Friends of Buckingham  
[info@friendsofbuckinghamva.org](mailto:info@friendsofbuckinghamva.org)  
<http://www.friendsofbuckinghamva.org/>  
<https://www.facebook.com/ProtectBuckingham>

**Critical information for public comments – omitted or inadequate data -- in draft air permit for the Union Hill, Buckingham VA compressor station; misinformation used by ACP to locate Compressor Station 2 in Union Hill. And, questions that must be answered before the Virginia Air Pollution Control Board could factually review this permit:**

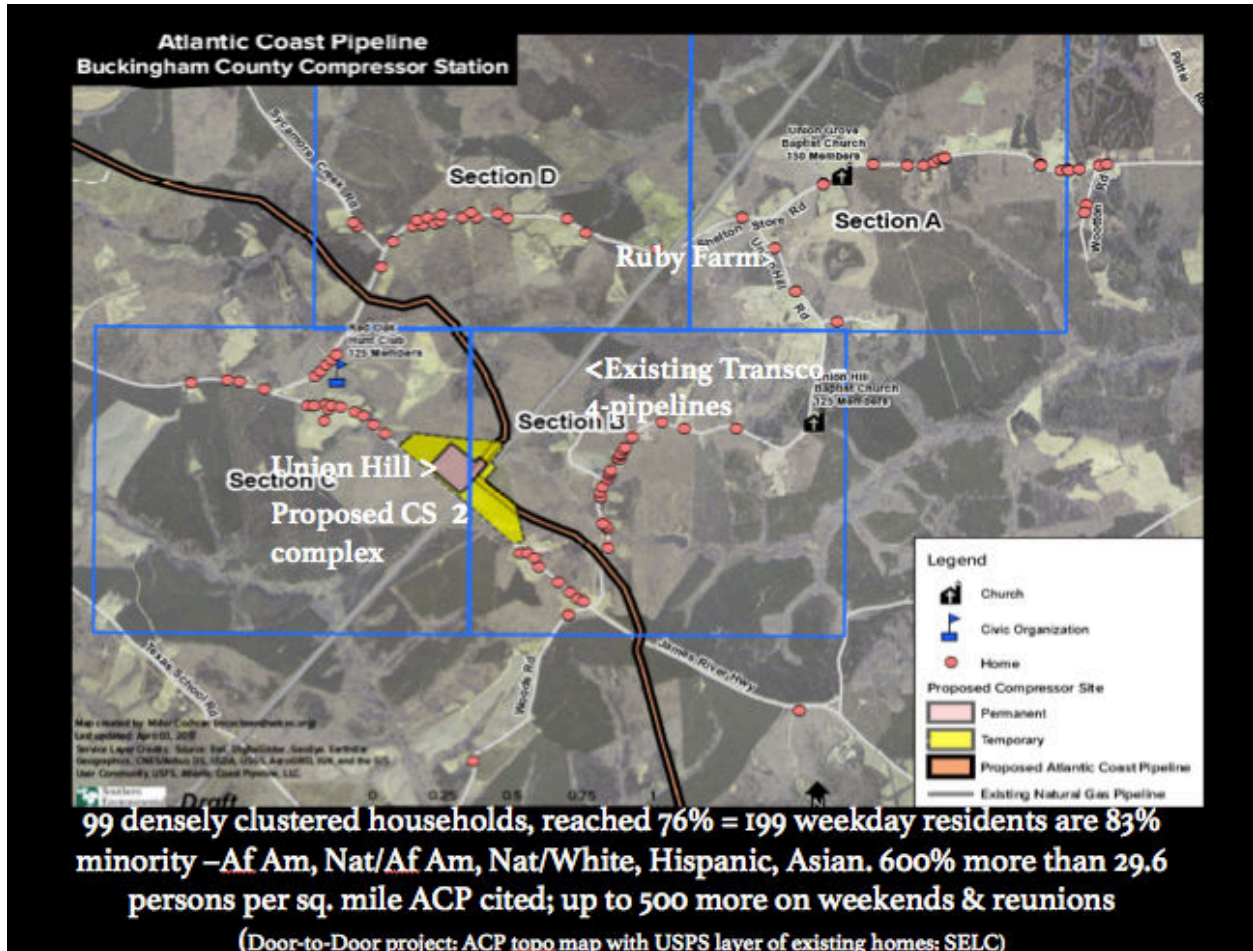
2. Dominion knowingly erased the existence of Union Hill as a known community, and its 99 households visibly within 150ft – 1-mile radius on all sides of their ACP VA compressor station site. In their 2015 FERC application and in all local and state permit processes both written and submitted at public hearings, ACP used the 2010 census average person per square mile data for the whole of Buckingham County – 29.6 – to report the population for ACP CS 2.
